Approved Section: 4.55 (1A) Application No: SSD-8647-Mod-2

Approved Section: 4.55 (1A) Application No: SSD-8647-Mod-2 Granted On: 25 July 2019 Sheet No: 2 of 13

HORNSBY KU-RING-GAI HOSPITAL STAGE 2

**HELIPAD ELEVATIONS &**

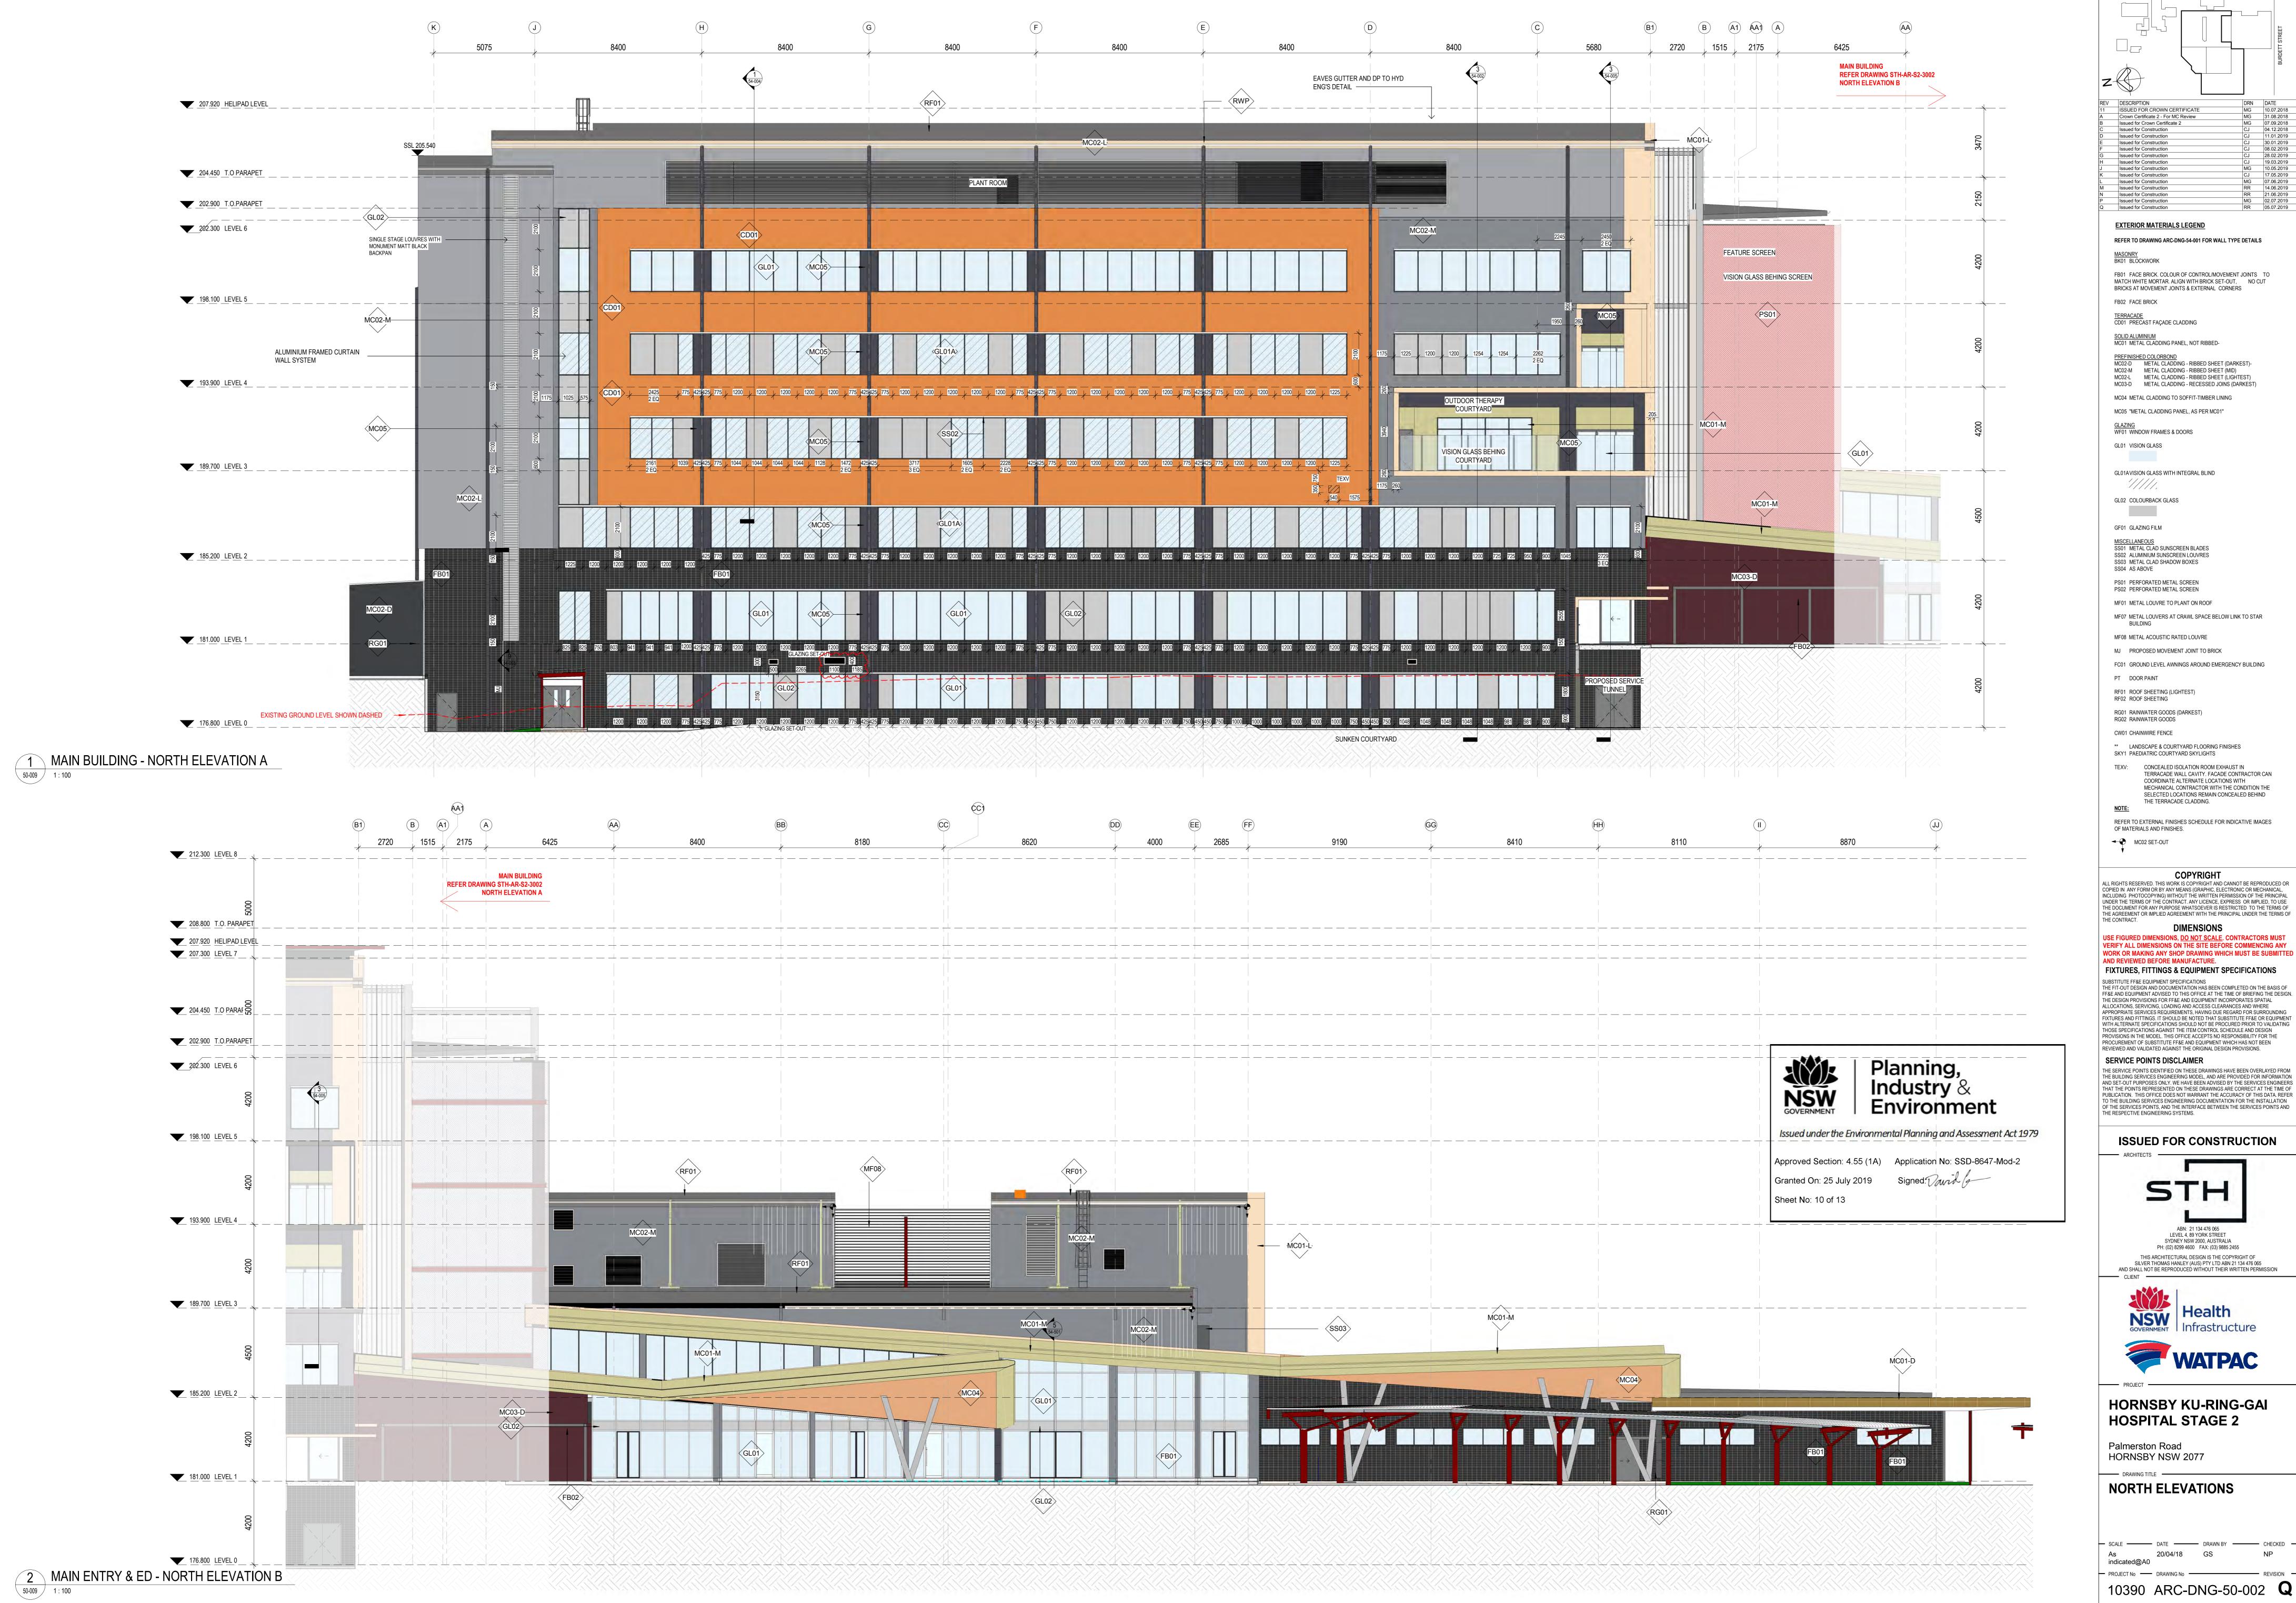
**CHANGES FROM SSD** HIGHLIGHTED IN YELLOW LIFT LOBBY ADDED STRUCTURAL STEEL FRAMING FOR THE SAFETETY NET LIFT SHAFTS EXTENDED FIRE STAIR EXTENDED LEVEL 6 PLANT ROOM ROOF METAL ROOF REPLACED WITH CONCRETE SLAB 207.920 HELIPAD LEVEL ---+-------202.300 LEVEL 6 198.100 LEVEL 5 193.900 LEVEL 4 \_\_\_\_\_\_\_ 189.700 LEVEL 3 H — — H — — — — — — — — — \_\_\_\_\_181.000 LEVEL 1 176.800 LEVEL 0 B HELIPAD ELEVATION B
1:200
